20-COA-0099
1315 S. 1st Street

Old Louisville Architectural Review Committee
Public Hearing

Bradley Fister, Historic Preservation Specialist
July 29, 2020

Site Photos

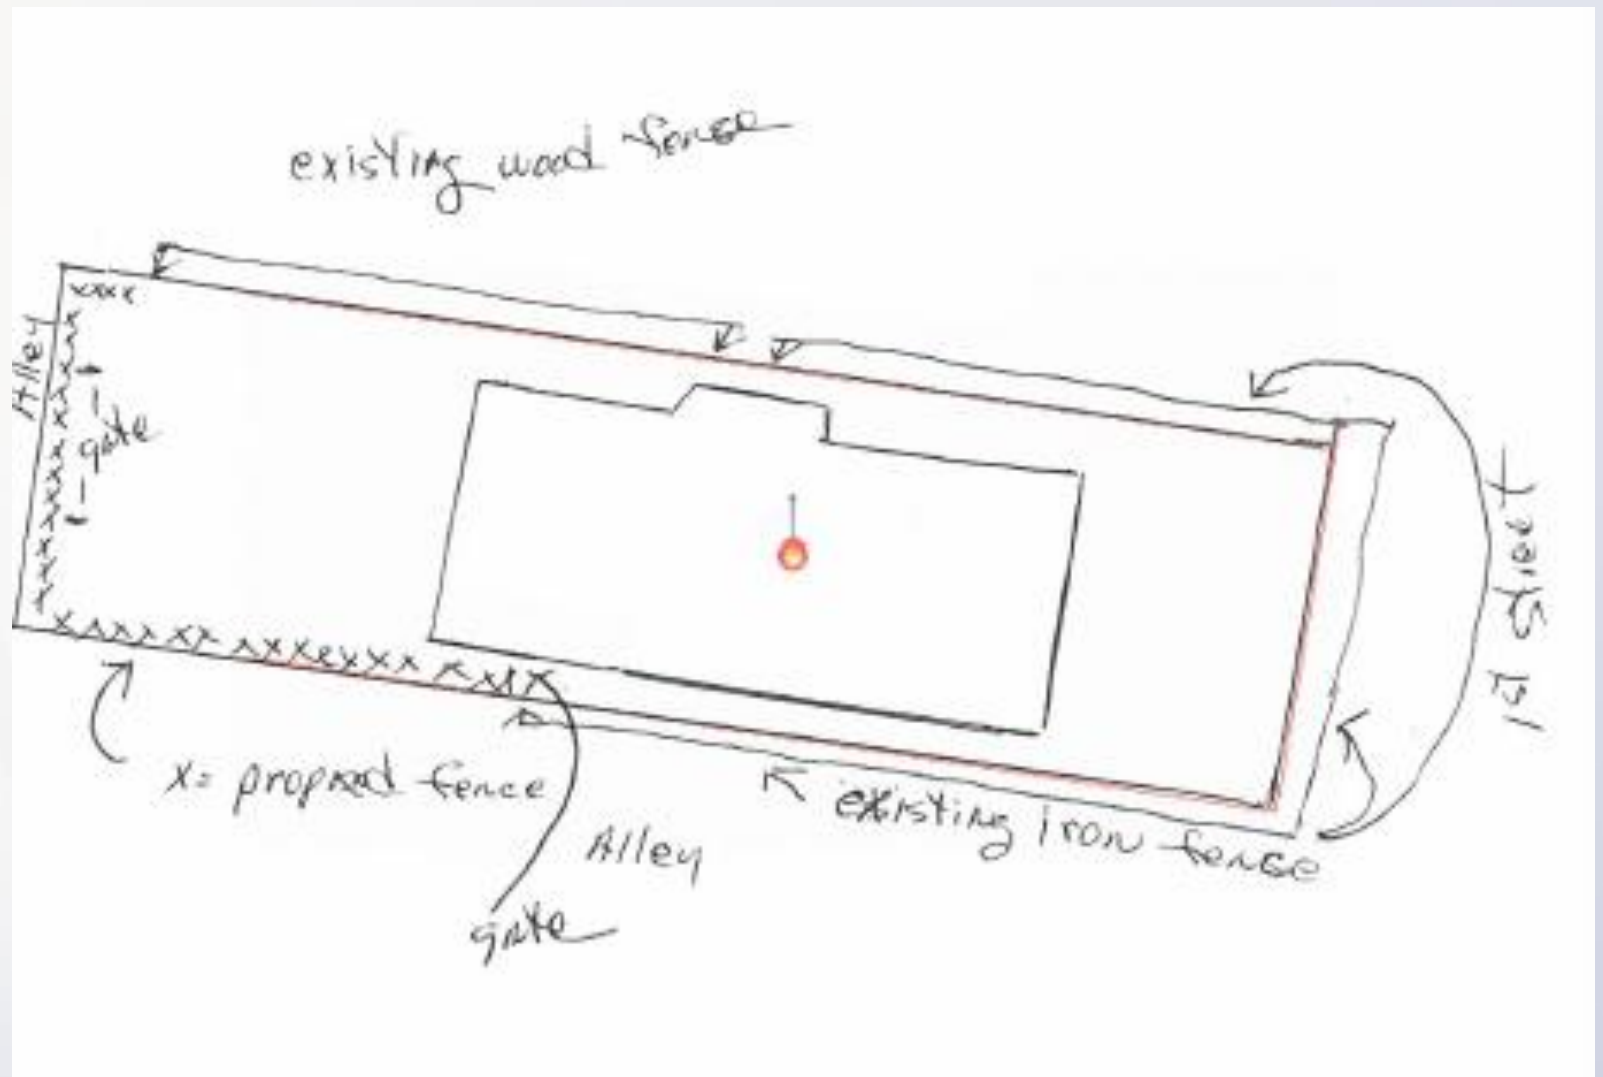
The proposed fencing generally meets the Old Louisville Design Guidelines for **Site**. The only conflict with the Design Guidelines relates to **ST10** which states that masonry walls should not be in street-visible locations unless there is a need for earth retention, screening, or historic precedent. The proposed location of the masonry fence posts is along to alleys.

In this case, the proposal is only for masonry columns rather than a solid wall which reduces the overall material. While visible from the alleys, the fence proposal would only be obliquely seen from 1st Street, if at all. The predominant fence structure will be wood which is in conformance with the Design Guidelines.

- 1. The applicant shall stain or paint the proposed wood fence within six months of being installed.**

2. The proposed fence and brick columns shall not exceed 7' in height and the finished side of the fencing shall be outward facing per ST15.
3. If the design or material changes, the applicant shall contact staff for review and approval.
